# DART SERVICE INSTRUCTION

TO AMEND INSTALLATION INSTRUCTIONS IIN-D044-719 REV. A  
AND INSTRUCTIONS FOR CONTINUED AIRWORTHINESS ICA-D044-719 REV. 0

REF TCCA STC: SH04-40

DRAWING NO. D3281  
TITLE FLOOR PROTECTOR  
SCALE NTS  
REV. F SHEET 1 OF 4

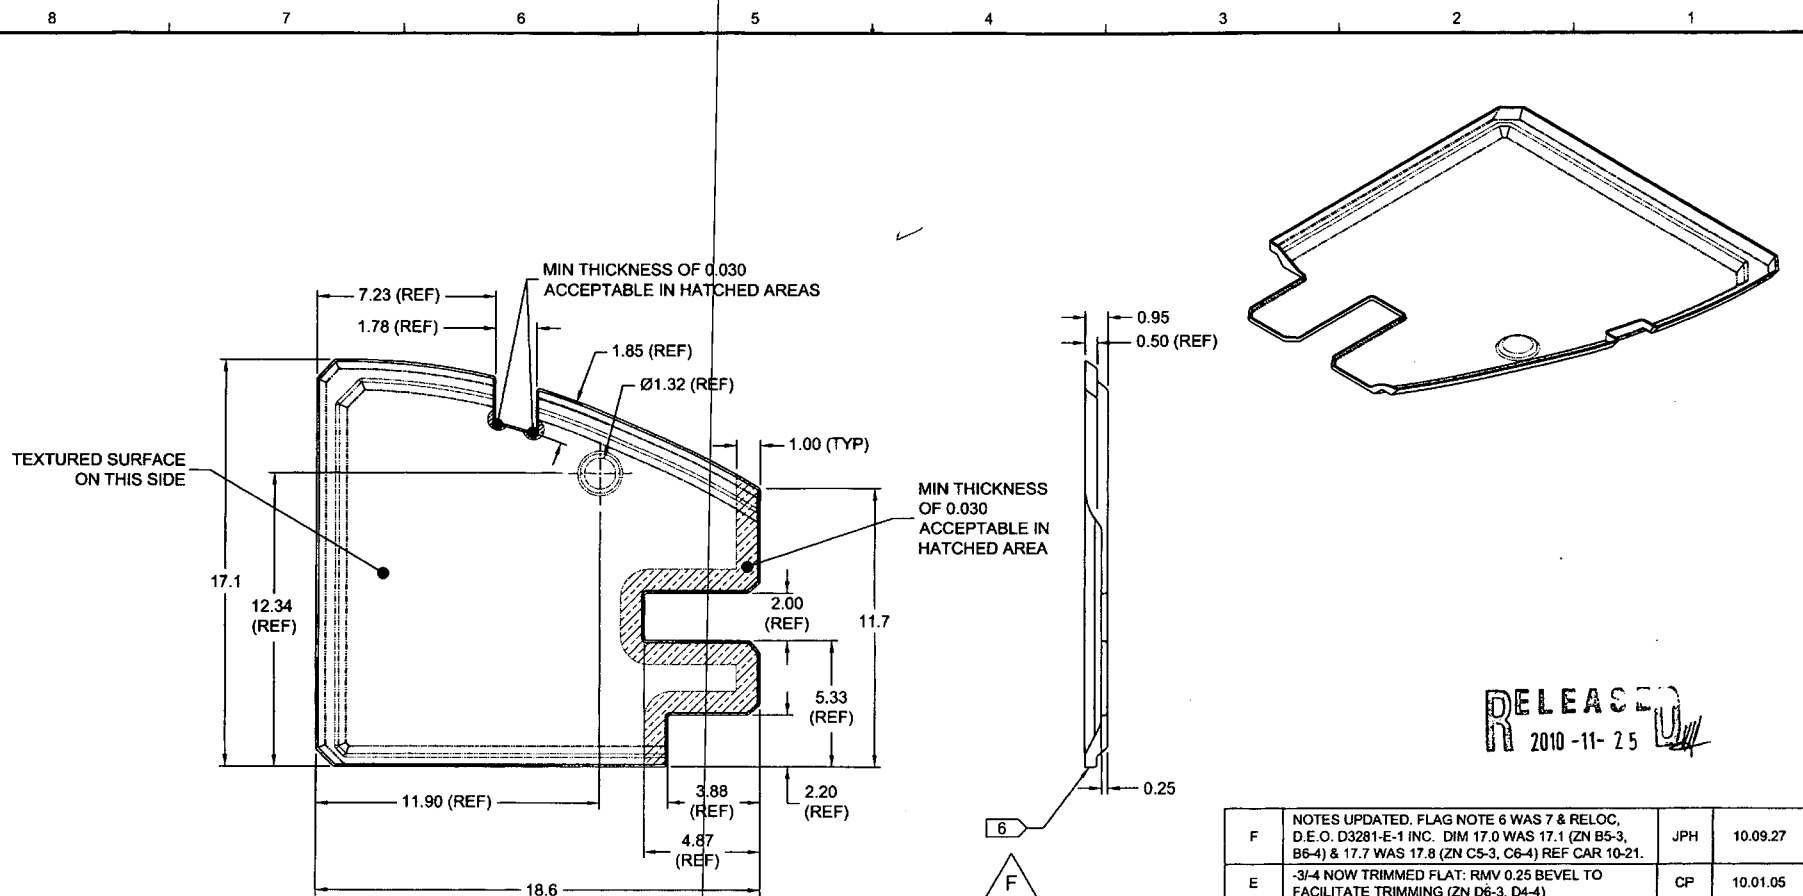
To add the D044-719-011L08 Clear Cabin Floor Protectors. The -011L08 kit is similar to the existing -011 kit, however the plastic is transparent instead of solid black. The existing D044-719-011 kit will be re-identified as D044-719-011L02.

The D044-719-011L08 Cabin Floor Protectors kit consists of four transparent plastic trays that are placed on the cabin floor to protect the carpets from damage. The -011L08 kit should be installed per the -011 kit of Installation Instructions IIN-D044-719 and maintained per Instructions for Continued Airworthiness ICA-D044-719. The parts list and weight & balance for the -011L08 kit is given below.

**D3281-1 FLOOR PROTECTOR**

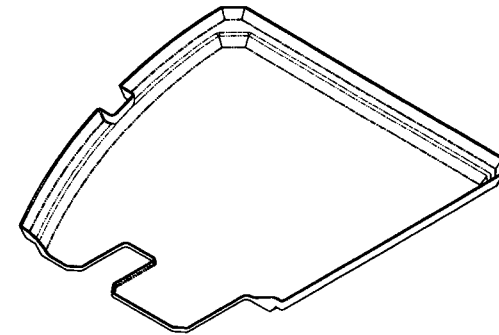
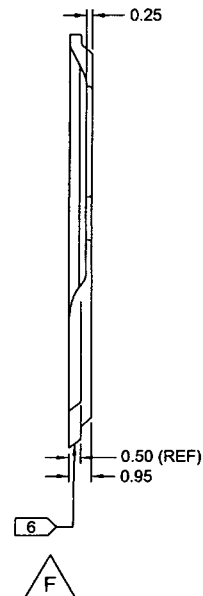
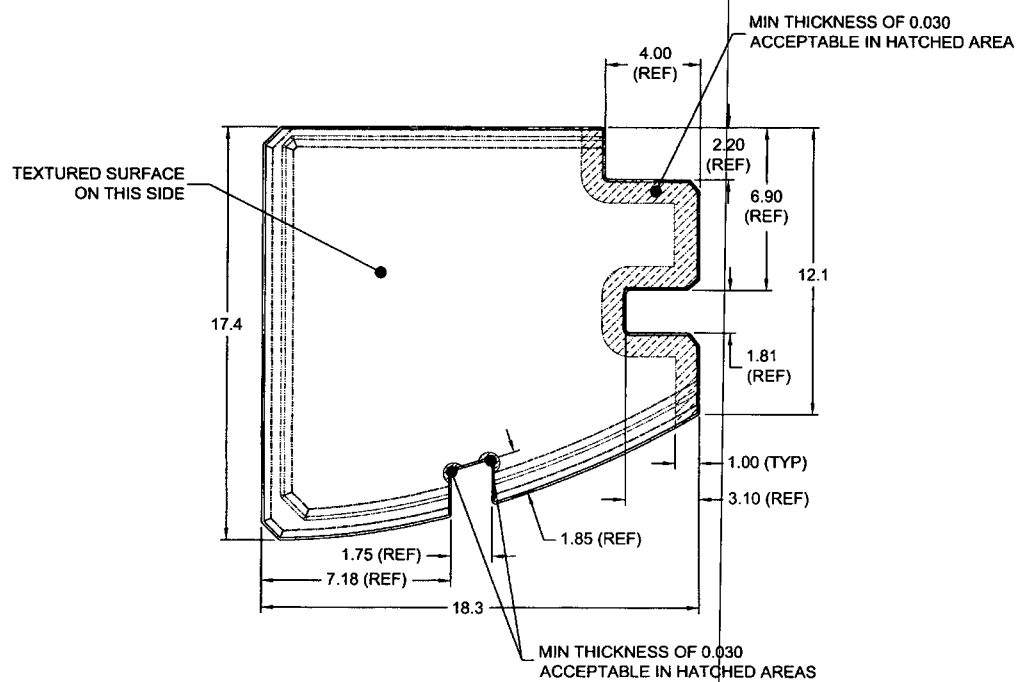
F	NOTES UPDATED. FLAG NOTE 6 WAS 7 & RELOC, D.E.O. D3281-E-1 INC. DIM 17.0 WAS 17.1 (ZN B5-3, B6-4) & 17.7 WAS 17.8 (ZN C5-3, C6-4) REF CAR 10-21.	JPH	10.09.27
E	-3/4 NOW TRIMMED FLAT: RMV 0.25 BEVEL TO FACILITATE TRIMMING (ZN D6-3, D4-4)	CP	10.01.05
D	THICKNESS 0.093 WAS 0.125, MIN THICKNESS 0.070 WAS 0.080, P/N AND B/N ID WITH VIBRATING STYLUS (ZN A7-1, A7-2, A7-3, A7-4); D3281-4 NOW ON PAGE 4; CORRECT WEIGHTS (ZN A8-1, A8-2, A8-3, A8-4)	PH	08.03.28
C	UPDATE DIMS TO MATCH PARTS: COLOUR 701 WAS 700; GENERAL UPDATE	LE	07.10.09
B	NOW LEXAN; DIMS AS MANUFACTURED	CP	05.11.25
A	NEW ISSUE	CP	04.05.03
REV.	DESCRIPTION	BY	DATE
DESIGN			
DRAWN			
CHECKED			
MFG. APPR.			
APPROVED			
DE APPR.			
DATE	10.09.27
